Site: 9910 Administration Sq.	Drawing: 801506	Project: 0000416	Drawn: Name	Notes:	Acme Builders Corp 1234 Oak Road Yorktown, NY 10598
Title: 1st Floor Office Remodel	Scale: 1/4" = 1' 0"	Date: 01/30/2017	Rev: A

2. Demolition vs. New vs. Existing Conditions

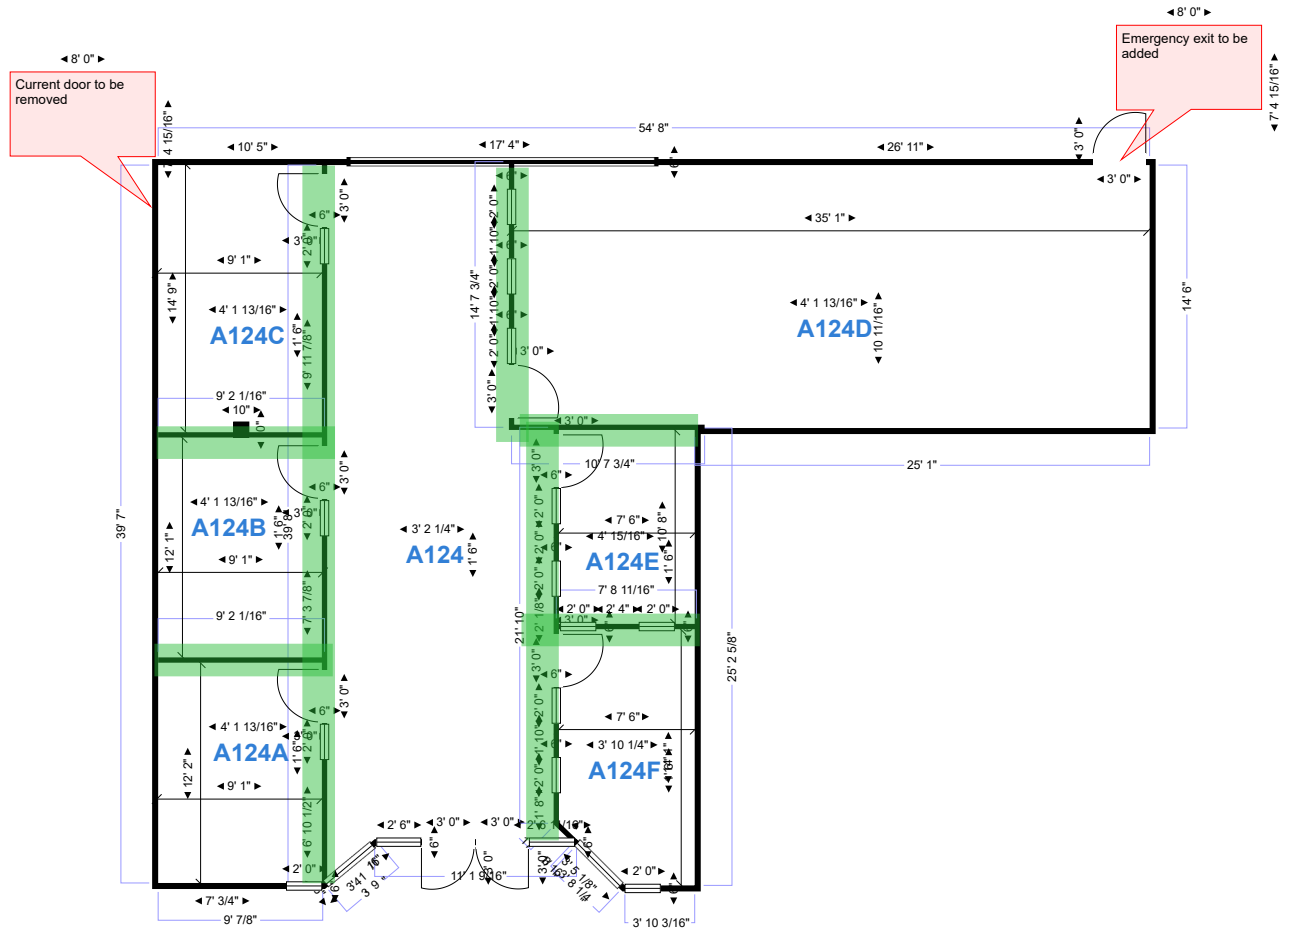
The scope mentions demolition; however, the drawings do not clearly indicate which walls are to be demolished, which are new, and which are to remain existing. Please provide clarification or a revised drawing identifying these conditions. Attached files. Red X are demo. Green highlighted are new.
